FIELD SERVICE BULLETIN

LVCCFSB2007 - 81 Anthony Bryan Monday, March 05, 2007 GSM - MOTOKRZR K1 - Board to Board Connector (Compatibility) GSM KRZR K1 2

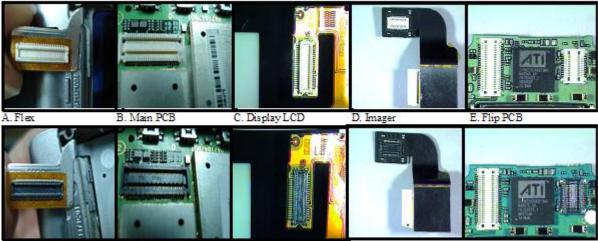
Service is aware of a component hardware compatibility issue that affects certain production models of GSM KRZR K1. After initial product ramp, Foxlink was brought up as a second source supplier for the board to board connectors used on the KRZR K1 product. The new Foxlink connectors are not compatible with the existing connectors supplied by Molex. Attempting to mate connectors that are miss-matched from each supplier will result in structural damage to the connectors. This change was managed in production by re-structuring the BOM and creating new part numbers to support both connector suppliers. The connector supplier can be determined visually by the color of the connector. Molex connectors are white and Foxlink connectors are black. See Images and Part Numbers below. The phone model number was also up suffixed to SJUGxxxxDA to reflect the new hardware.

Molex Connectors (White)

Foxlink Connectors (Black)

Service Teams should use the images above to determine the connector supplier and replace only with the corresponding part number for that supplier. See matrix below.

- 1. Visually inspect the original connectors to determine the supplier.
- 2. Replace using only the corresponding part number for that supplier.
